RE: Request to Approve Change Order 8

**CHANGE ORDER INFORMATION:**  
Change Order Number: 008

# Change Order Request 9 - PCO #27 - RFP #4 - Press Box Data Revisions

# REQUEST FOR PROPOSAL

5 ATHLETICS PRESS BOX - ADDITIONAL POWER/SYSTEMS  
1" = 1'-0"

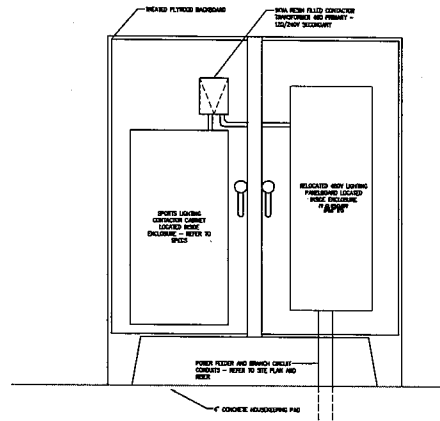
- Item 1:** REFERENCE Drawing E1.2 - Clouded REV 4 - Changes/Clarifications summarized here:
- Clarified roof and soffit speaker conduits back to sound system.
  - Clarified conduits to sound system.
  - REMOVE additional sound system power from EC (power already provided in press box package)
  - REMOVE additional wiremold scope from EC to IDF (wiremold at desks already included in press box package)
  - Clarified conduits to IDF vs wiremold.
  - Clarified IDF floor integral pull box by press box vendor.
  - Clarified additional devices/boxes for CCTV and WAPS by others (owner) for coordination purposes.
  - Clarified primary electric disconnects that had discussed being moved to under press box at a previous meeting.
